**ADDENDUM NO. 2**

**HERNDON STATION METRO GARAGE  
 CONTRACT NO. CN16100006  
 PROJECT NO. TF-000020-001**

This addendum is supplementary to the contract documents for the Herndon Station Metro Garage in Herndon, Virginia.

2 STAIR A ROOF PLAN  
1/8" = 1'-0"

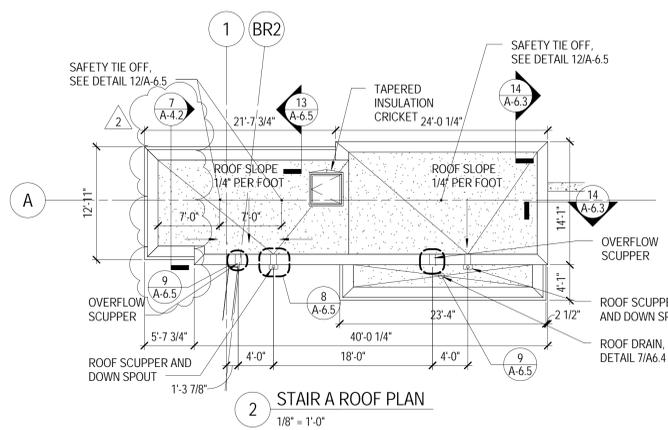
2.18	A-1.8	Detail 2: Section reference call out added to Roof Plan
2.19	A-2.1	Detail 1: Revised spandrel material note
2.20	A-2.9	Details 1, 2, 3: Revised note for aluminum mesh material

3 WALL SECTION  
1/4" = 1'-0"

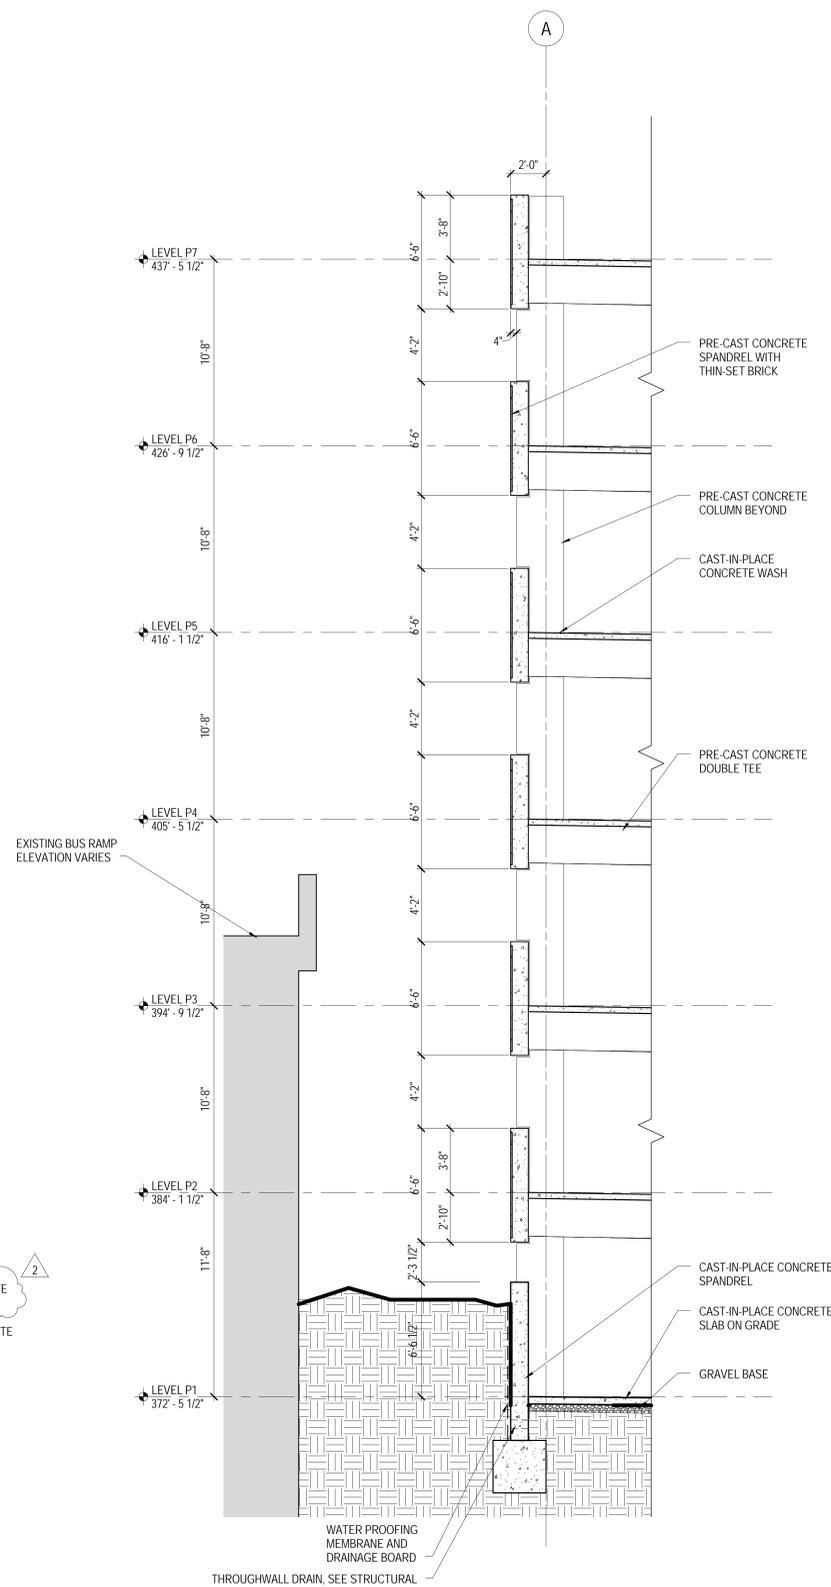
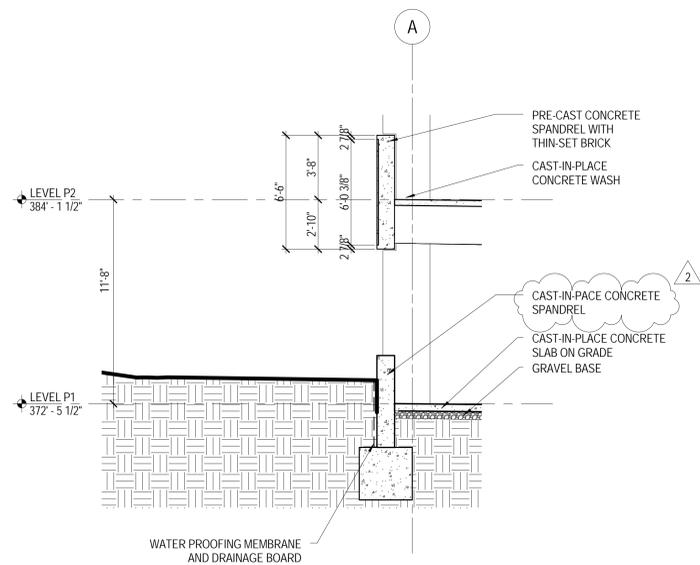
2.21	A-3.6	Detail 3; Revise spandrel note.
2.22	A-4.1	Detail 1-8: North side stair risers shifted 11" to the east side to miss the precast beam support under the stair landing Detail 2: Dimensions clarification

8 SECTION DETAIL - BRIDGE TO EXISTING GARAGE P4 LEVEL  
1" = 1'-0"

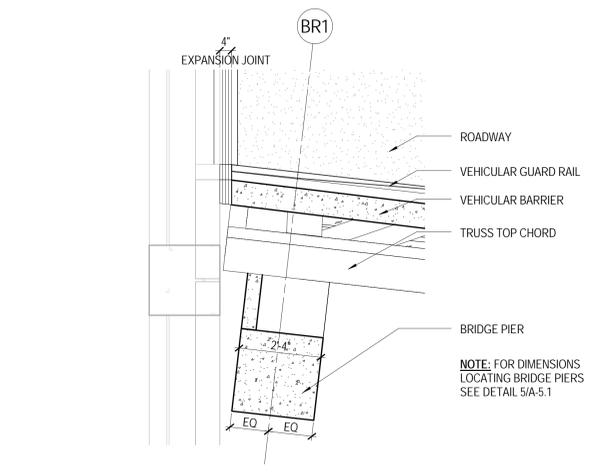
2.24	A-5.2	Detail 1 and 2; Revise coping material
2.25	A-5.3	Detail 2; Revise coping material
2.26	A-5.7	Detail 8; Revise coping material
2.27	A-5.8	Details 3 and 7; Revise coping material

8 STAIR A - FIXED LADDER - PLAN  
1" = 1'-0"

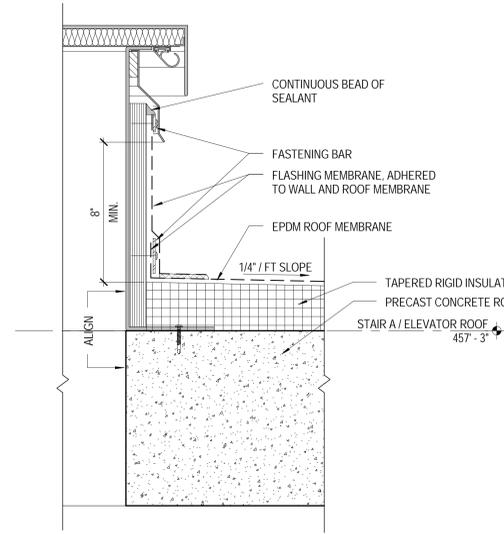
2.28	A-6.4	Detail 8; revise ladder notes
2.29	A-6.6	Glass Type clarification
2.30	SEC-1	Revised note #8 to include Monitor/CPU as equipment that requires UPS and Backup Generator. Added note #12 to install CCTV Monitor and CPU.
